This article was first published in issue #42, December 1995

## Z-100 Field Service Bulletins

by Steven W. Vagts  
Editor, "Z-100 LifeLine"

### Z207 Schematic

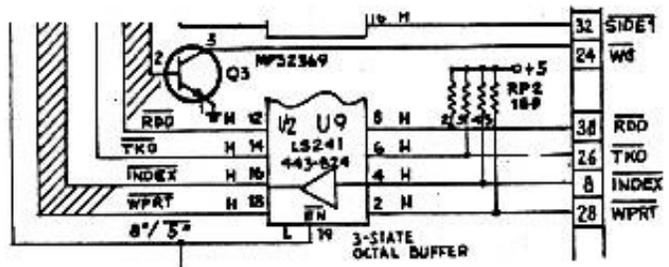
Locate the lower portion of U9 (near the 5" interface connector) and change the buffer symbol as follows:

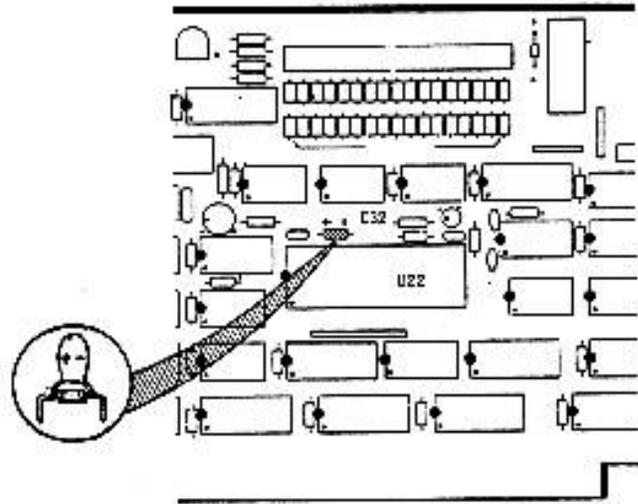
When troubleshooting a color video board, make sure that control R301 is in its fully CCW position as viewed from the component side of the board. If this control has been adjusted by the customer to a position other than CCW, a dim display may result.

Figure 026.

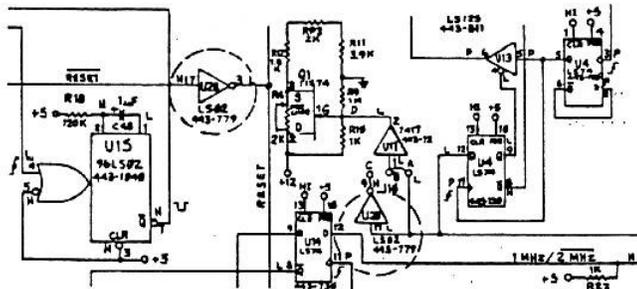
Locate the two inverter sections labeled "U28" beside "U15" and "U14" on your schematic (see figure 026) and change to "U10."
